Busselton Wastewater Treatment and Disposal

**Report and Recommendations
of the Environmental Protection Authority**

**Environmental Protection Authority
Perth, Western Australia
Bulletin 945
July 1999**

Assessment No. 1132

Figure 4. Plan of upgraded Busselton Wastewater Treatment Plant.

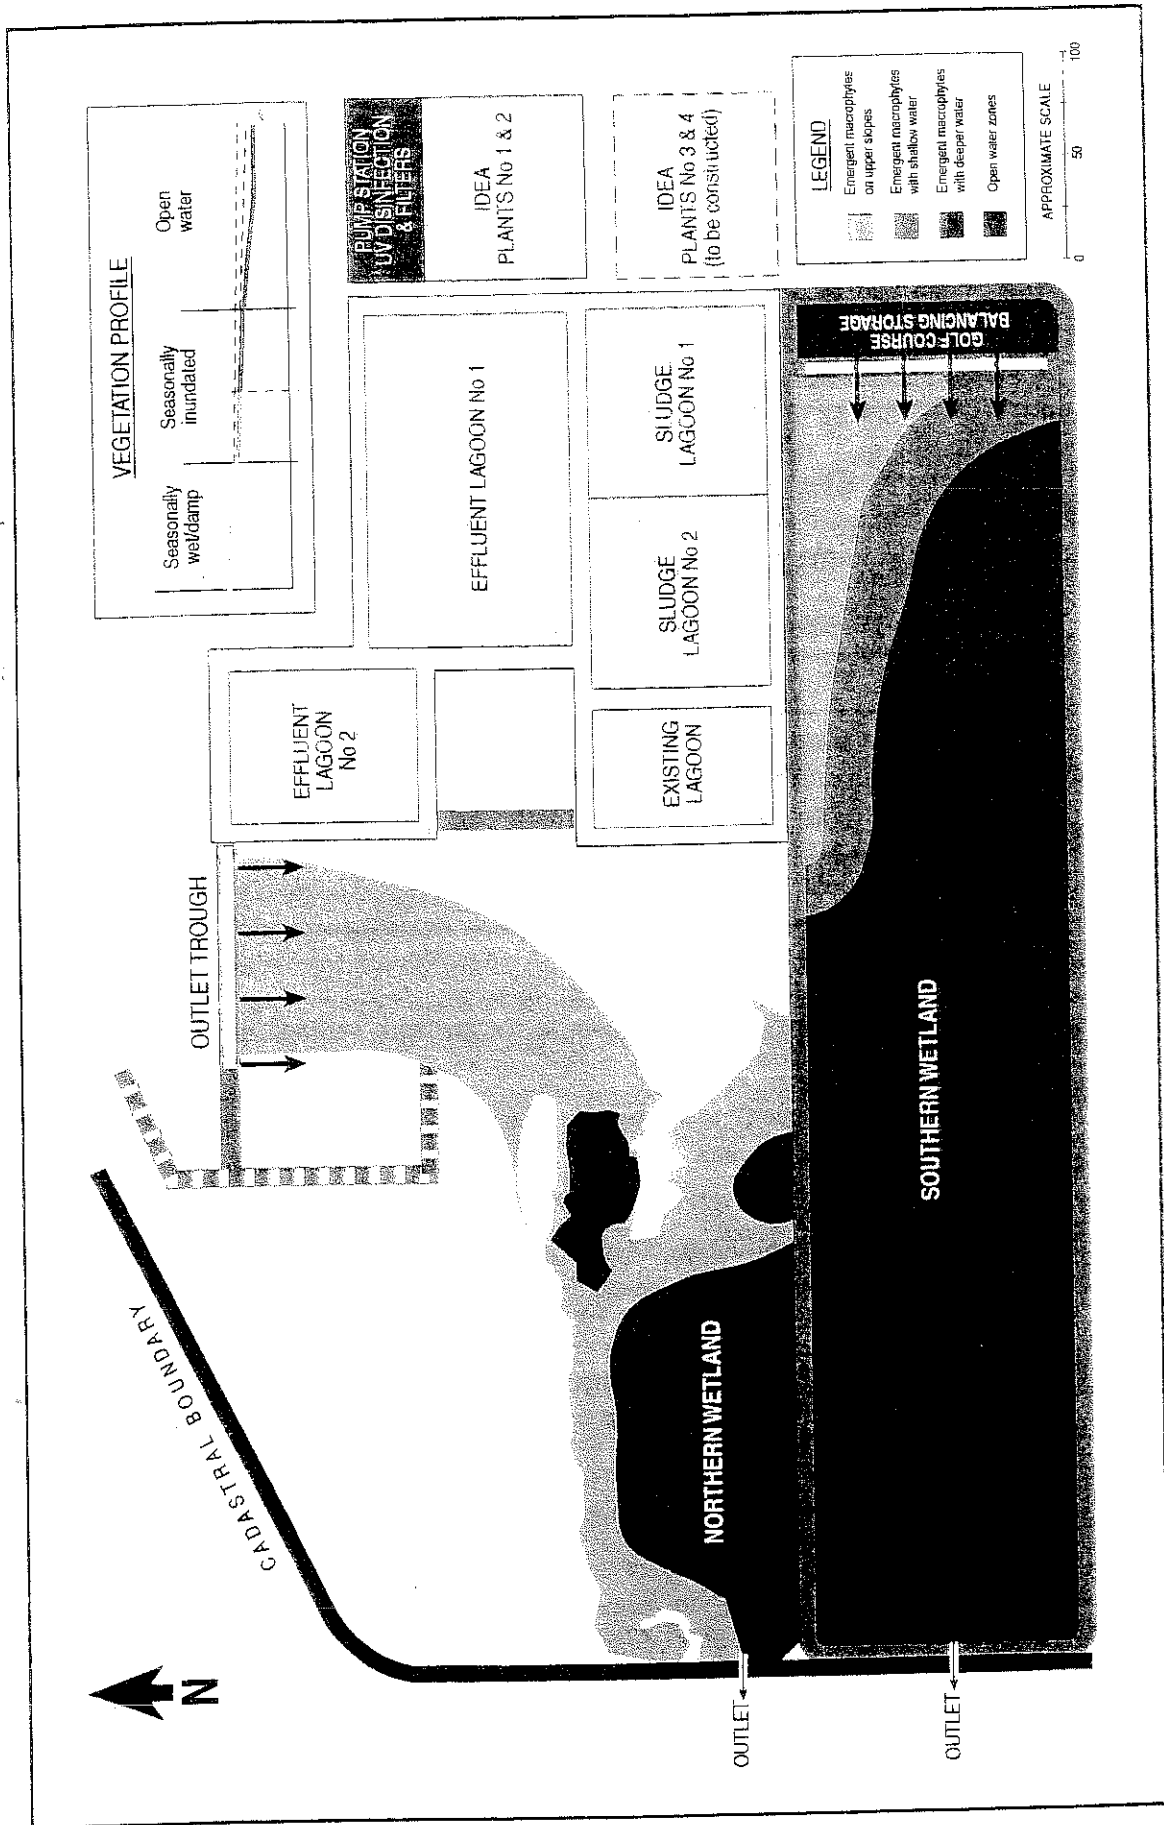
- Construction of an additional emergency storage lagoon between the two existing effluent lagoons increasing the emergency storage capacity from a minimum of 24 hours to 48 hours (Figure 4).

Figure 3.1 Proposed vegetation zones for constructed wetlands

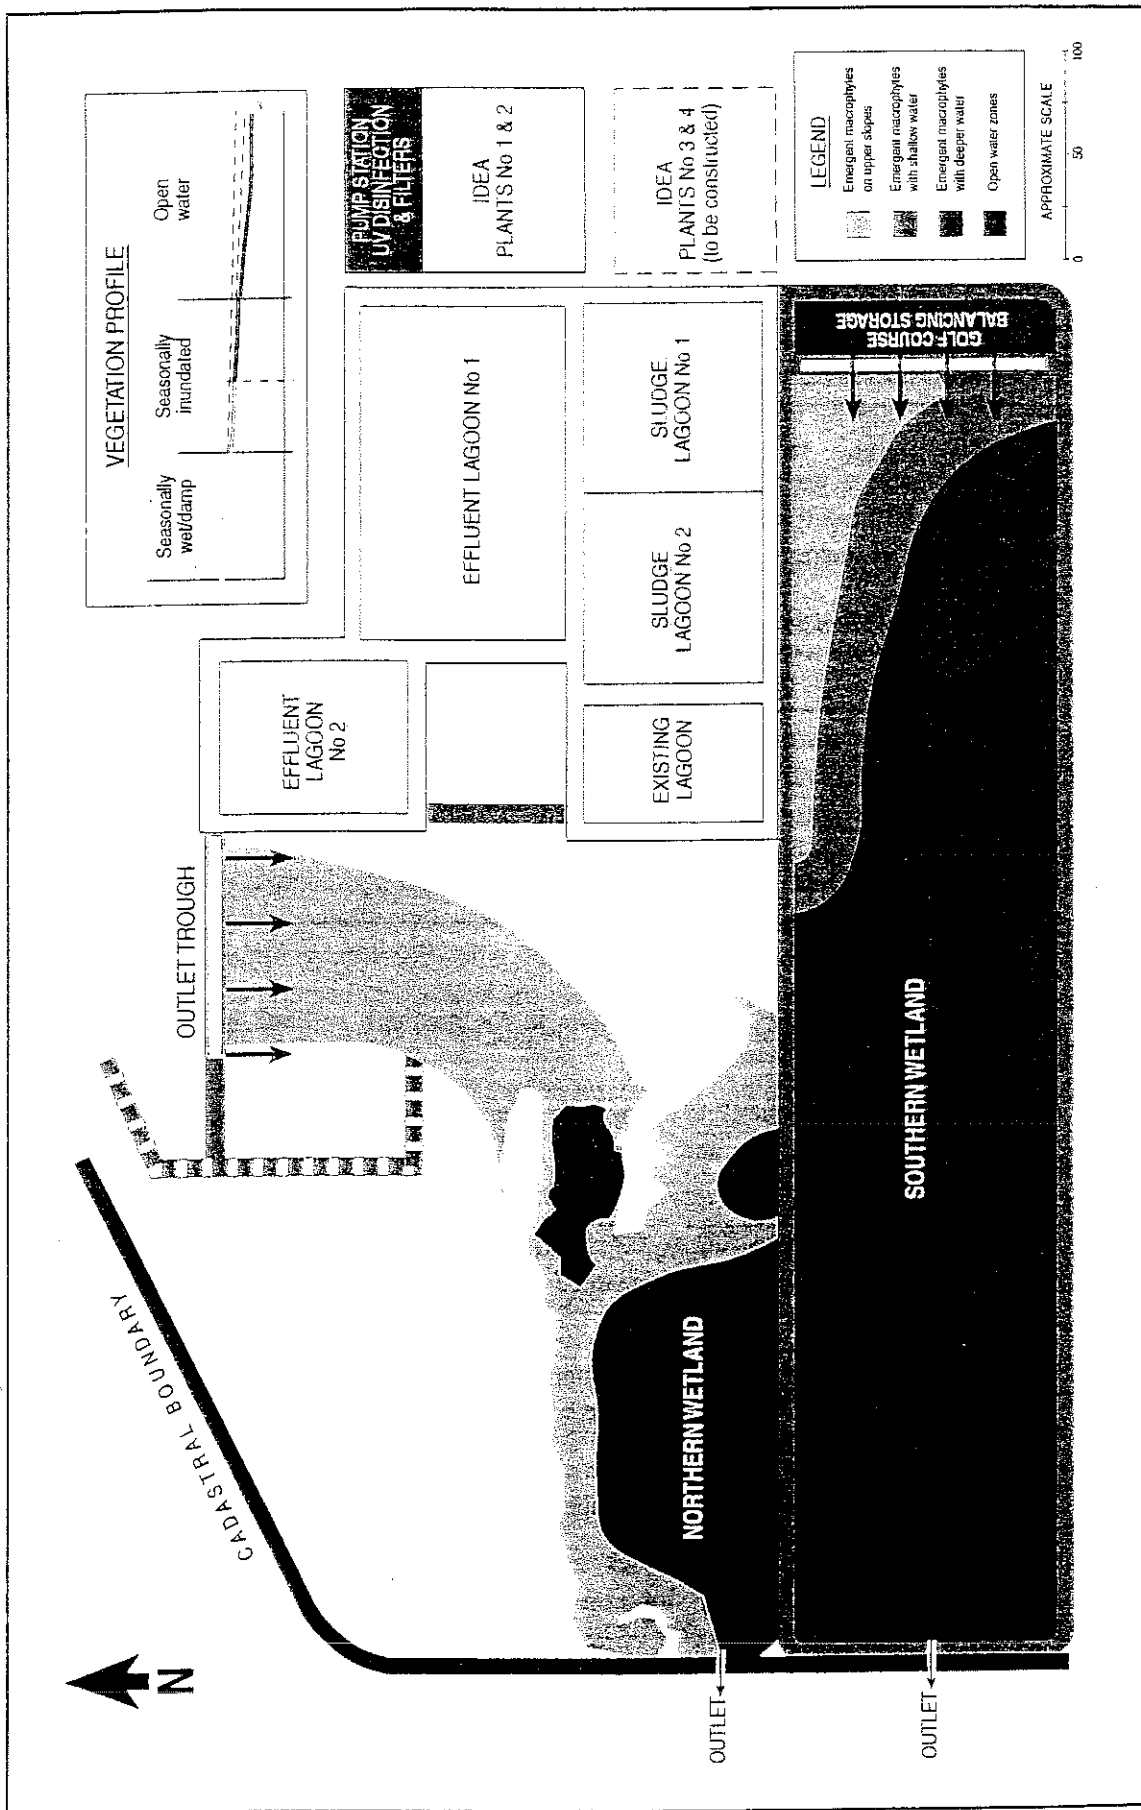
The Water Corporation proposes to upgrade the southern part of the existing wetland and to release the majority of the treated wastewater to this area (see Figure 3.1). The reasons for choosing to upgrade this area as a constructed wetland to provide the final polish for the treated wastewater are:

Figure 1
Variation of median thermotolerant coliform concentrations with distance downstream in the drain system

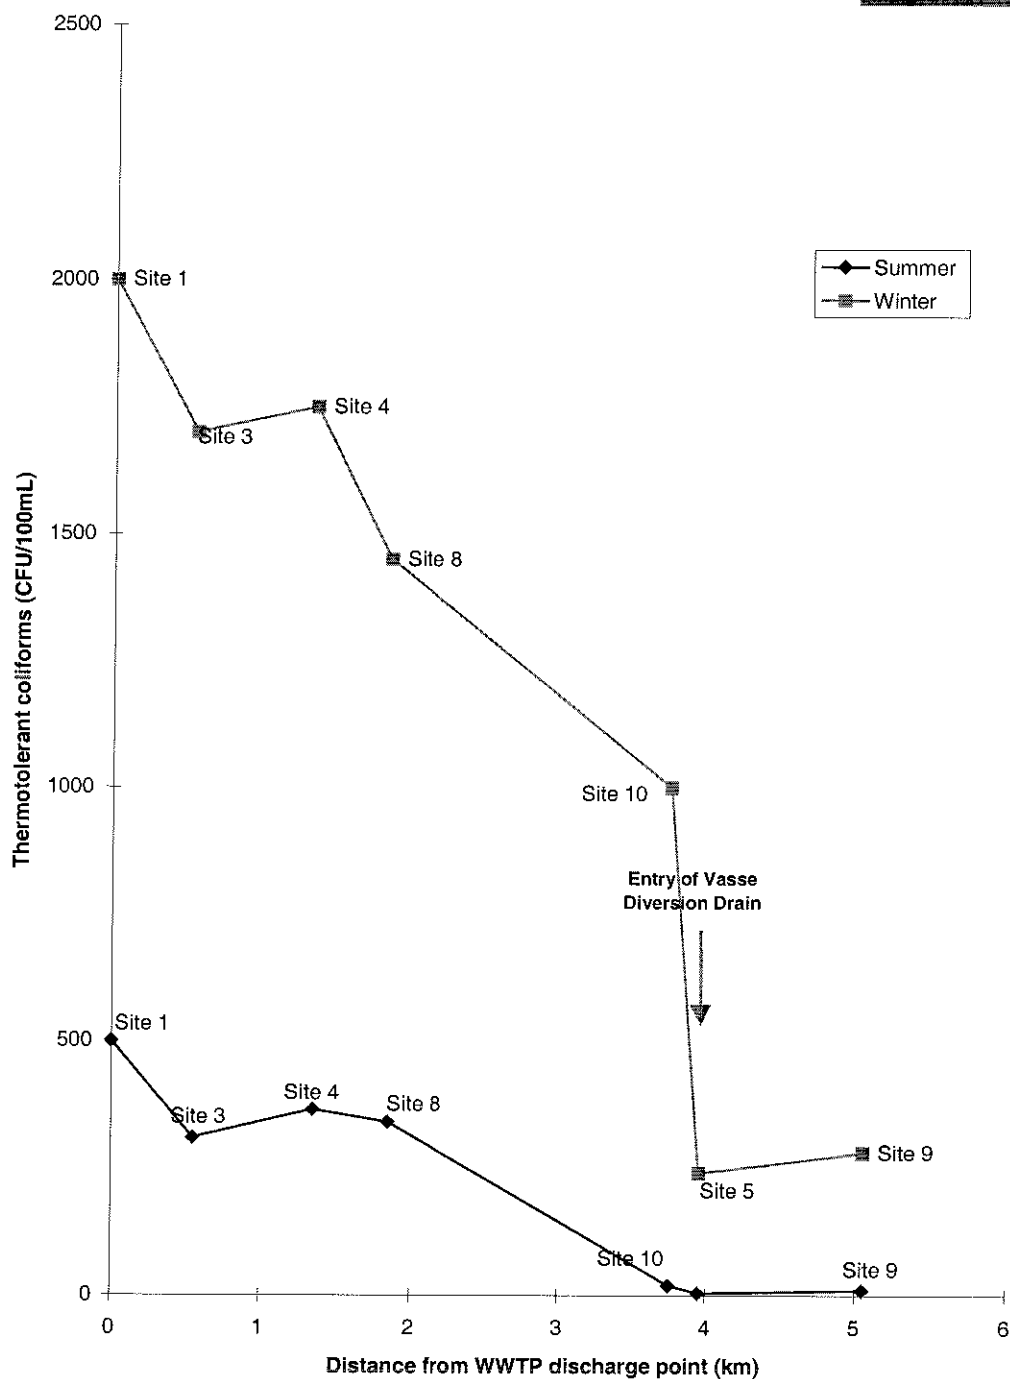
Since the CER was released, the regular sampling program has continued and additional data (primarily for winter, but with some additional summer data) are now available. A revised Table 4.2 and Figure 4.4 are presented in Table 1 and Figure 1. Over 120 samples (in total) have now been collected in the drains affected by and immediately surrounding the WWTP. Another 65-70 samples (in total) have been collected in the Vasse Diversion drain. In addition, thirteen samples have now been taken within 10 m of the mouth of the drain.

The data suggest that in summer, median bacterial concentrations decrease with distance along the drain. Further, in summer, the current data suggest that the median bacterial level at site 10, which is above the intersection of the Vasse Sub-A Drain with the Vasse Diversion Drain, is lower than the guideline of 150 cfu/100 mL for primary contact recreation. The additional data also give added confidence that the median bacterial level along the beach at Busselton in summer is 10 cfu/100 mL, well below the guideline of 150 cfu/100 mL for primary contact recreation.
